APPROVED FIRE CODE PLANS
Reviewer: M. Morris
All code deficiencies found in the field shall be corrected and made compliant prior to the Certificate of Compliance being issued.

BROTHERS BUSINESS CENTER V
BUILDING REMODELING AT

17625 KEITH HARROW BLVD.
HOUSTON, TX 77084

DRAWING TITLE:
PROPOSED FLOOR PLAN

1 PROPOSED FLOOR PLAN
Scale: 1/8" = 1'-0"

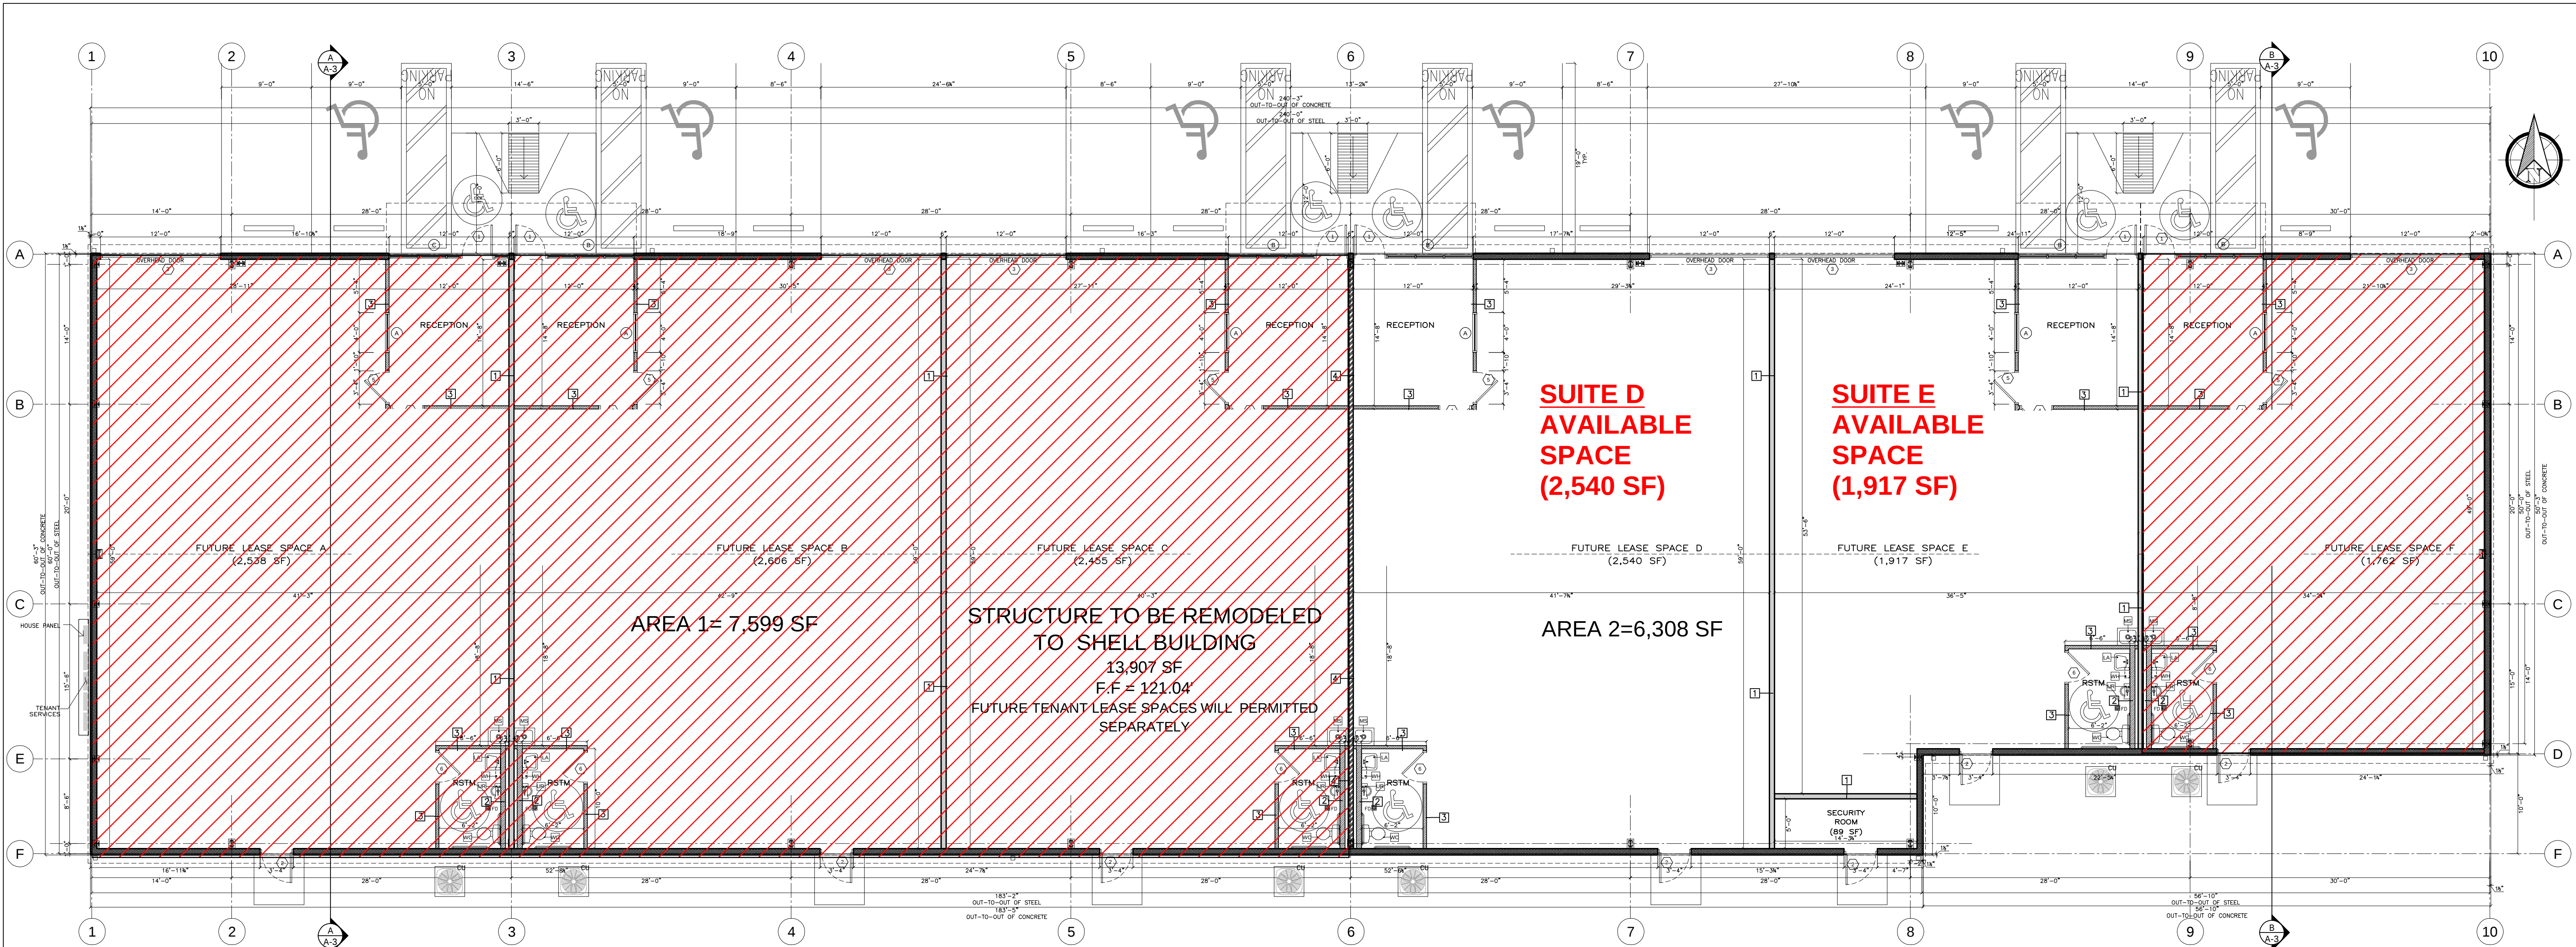
SEE EXIT LIGHTING PER. SECTION 1013 (2018 IFC)

SEE EXIT DISCHARGE ILLUMINATION PER 1008.2.3 (2018 IFC)

The locking device is readily distinguishable as locked.
